Item Name: 205 Skidtube bent detail

DRAWING NO. D2580	TITLE 205 SKIDTUBE ASSEMBLY	REV. E	DART AEROSPACE LTD ENGINEERING ORDER	D.E.O. NO. D2580-E-1	SHEET NO. SHEET 1 OF 1	SCALE NTS
DRAWN <i>UP</i>	CHECKED <i>ASS</i>	MFG. APPR. <i>ER</i>	APPROVED <i>[Signature]</i>	DE APPR. <i>[Signature]</i>		
DATE 11.12.13	DATE 11.12.13	DATE 11.12.13	DATE 11.12.13	DATE 11.12.13

CHANGE ALL C'BORED WELDED CROSSBOLT SPACERS TO SWAGED SPACERS

SECTION B-B, F-F, I-I
NOT TO SCALE

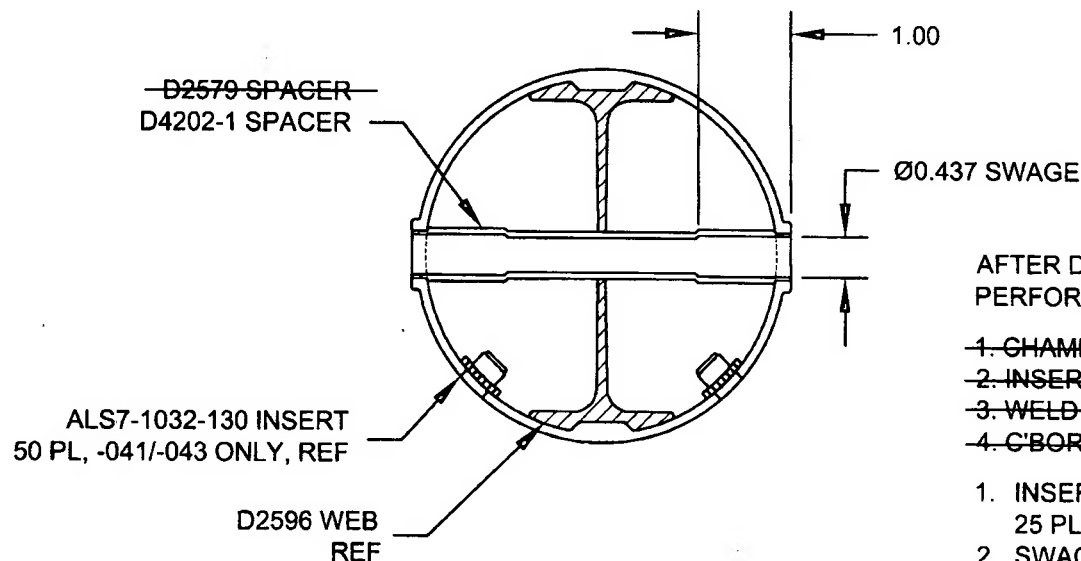
SECTION B-B, SECTION F-F, & SECTION I-I ARE AMENDED AS FOLLOWS
FOR ALL HOLES THAT WERE ORIGINALLY C'BORED:

- ~~1. CHAMFER HOLE 0.050 X 45°~~
- ~~2. INSERT D2579 SPACER (20 PLACES)~~
- ~~3. WELD INTO PLACE AND GRIND FLUSH~~
- ~~4. C'BORE D2579 SPACER TO Ø0.437 X 1.00 DEEP~~

1. INSERT D4202-1 SPACER, 20 PL (-041) OR 20 PL (-045) OR 25 PL (-047)
2. SWAGE TO Ø0.437 X 1.00 DEEP PER QSI 002
3. TRIM / GRIND FLUSH PER QSI 002
